South Texas Project Electric Generating Station 4000 Avenue F – Suite A Bay City, Texas 77414

South Texas Project
Units 3 and 4
Docket Nos. 52-012 and 52-013
Response to Request for Additional Information

RAI 02.05.04-1:**QUESTION:**

Figure 1: Subsurface Profile at Unit 4 Radwaste Building

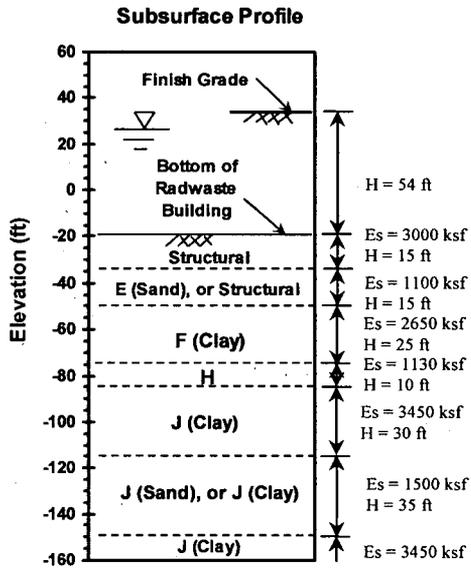
Figure 2.5S.4-2, Power Block Plan STP COLA site, does not show borings located within the footprint of the STP 4 Radwaste building or the pump houses at the UHS Basin. The STP Unit 4 Radwaste building substructure and UHS structure are Category 1 safety related structures (see ABWR DCD Table 3.2-1). Soil profiles underlying specific structures may vary from site-wide soil properties, and soil data within the footprint of each Category 1 structure is specified by Regulatory Guide (RG) 1.132. Please provide static and dynamic soil data and the related stability analyses for the Radwaste Building and UHS structure, based on considerations of subsurface data obtained at those locations.

The subsurface profile beneath the Unit 4 Radwaste Building based on the supplemental investigation results is shown on Figure 1. The subsurface profile beneath the UHS based on the results of the original and the supplemental investigations is shown on Figure 2. These figures indicate the thickness of each layer and the high strain (or static)

elastic modulus (E_s) and the stratum thickness (H) employed in the settlement analysis described in (3) below.

Estimated pre-consolidation pressures exceeded the combined stresses from existing overburden and applied load at the center of each stratum, and thus virgin compression was not considered. The computed average settlement beneath the Unit 4 Radwaste Building = 0.8 inches.
